SUBJECT: ISSUANCE OF AMENDMENT NO. 80 TO FACILITY OPERATING LICENSE NPF-35  
AND AMENDMENT NO. 74 TO FACILITY OPERATING LICENSE NPF-52 - CATAWBA  
NUCLEAR STATION, UNITS 1 AND 2 (TACS 66667 and 66668)

AMENDMENT NO. 80 TO FACILITY OPERATING LICENSE NPF-35 - Catawba Nuclear Station, Unit 1  
AMENDMENT NO. 74 TO FACILITY OPERATING LICENSE NPF-52 - Catawba Nuclear Station, Unit 2

ATTACHMENT TO LICENSE AMENDMENT NO. 80

FIGURE 5.1-1  
EXCLUSION AREA

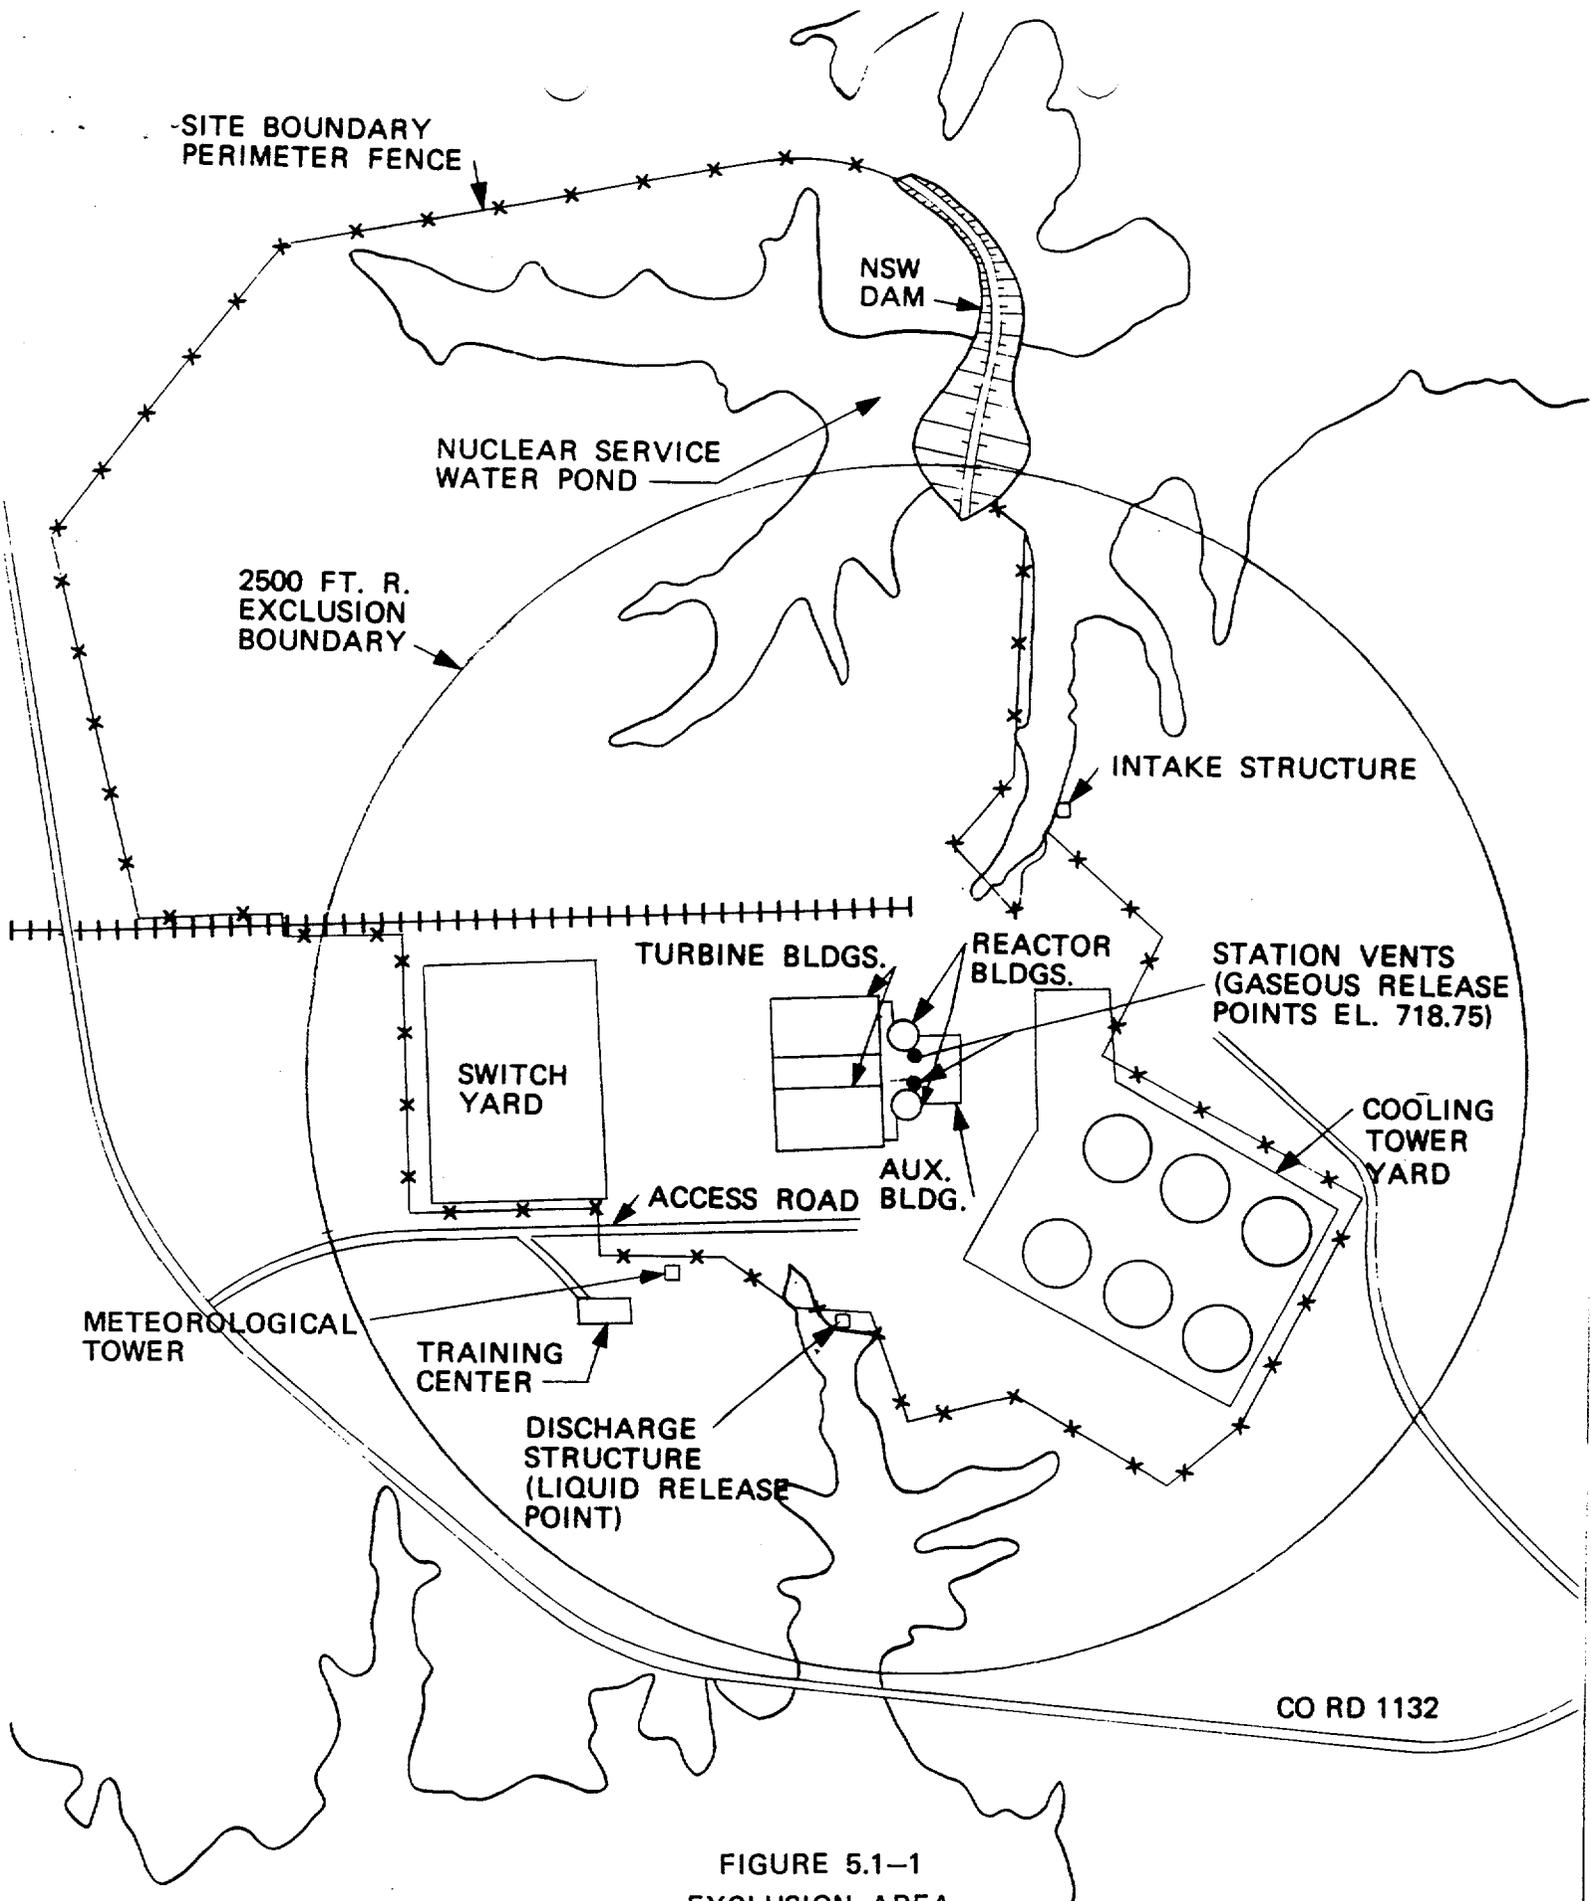
10. Revision to include updated Figures 5.1-1, 5.1-3 and 5.1-4 to reflect site configuration. This is an administrative change.
11. Revision to TS 6.2.2f. to reflect the shift rotation and work hours at Catawba is being handled separately.

5.1.1 The Exclusion Area shall be as shown in Figure 5.1-1.
